Access Compliance Report

Public Rights-of-Way

Intersection ID: 31894	Main Street: GREEN_MOUNTAIN_RD	Cross Street: MOUNTAIN_SPRINGS_DR	Location: SW
ADA ID: B8E22C36DA21	Ramp Type: PerpDiag	Initial Pass/Fail: Fail	Overall Compliance: No
Codes/Mitigation Info/Possible Solution		Field Measurements/Component Compliance	
Severity Score: 21.25

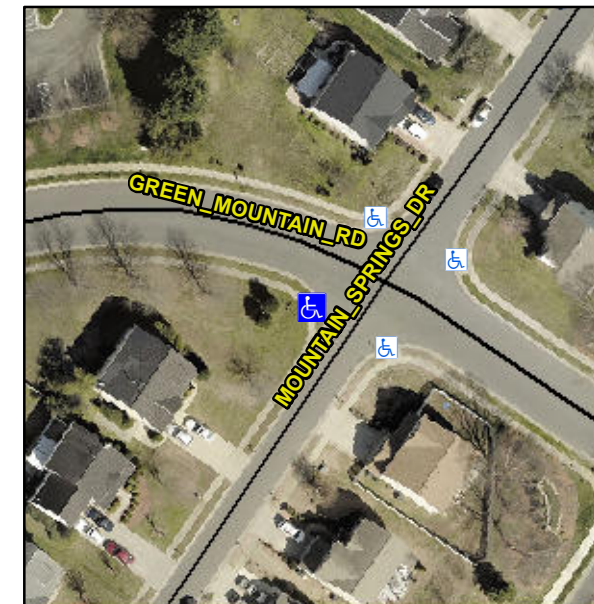
Not Found, R304.5.1, R304.5.3

Compliance	Description	Data	Compliance	Description	Data
N/A	Ramp Length (in)	46.0	Yes	Ramp Slope (%)	5.7
No	Ramp Width (in)	41.0	No	Ramp XSlope (%)	5.7
N/A	Flare Type LT	N/A	N/A	Flare Type RT	N/A
N/A	Flare Slope LT (%)	N/A	N/A	Flare Slope RT (%)	N/A
N/A	Flare Traversable LT?	N/A	N/A	Flare Traversable RT?	N/A
N/A	Landing Length (in)	N/A	N/A	DWS Provided?	N/A
N/A	Landing Width (in)	N/A	N/A	DWS Contrast?	N/A
N/A	Landing Slope (%)	N/A	N/A	DWS Length (in)	N/A
N/A	Landing X Slope (%)	N/A	N/A	DWS Full Width?	N/A
N/A	Landing Curb? (Y/N)	N/A	N/A	DWS Offset (in)	N/A
N/A	Shared Landing?	N/A			
N/A	Gutter Ponding?	N/A	N/A	Gutter Slope (%)	N/A
N/A	Gutter Lip Ht (in)	N/A	N/A	Gutter X Slope (%)	N/A
N/A	Painted X Walk1?	No	N/A	Painted X Walk2?	No
	X Walk 1 Direction	To SE		X Walk 2 Direction	To NE
N/A	X Walk 1 Width (in)	N/A	N/A	X Walk 2 Width (in)	N/A
	X Walk 1 Slope (%)	3.7		X Walk 2 Slope (%)	2.2
	X Walk 1 X Slope (%)	2.0		X Walk 2 X Slope (%)	4.0

Remove & Replace Curb Ramp With Two New Directional Ramps or Equivalent.
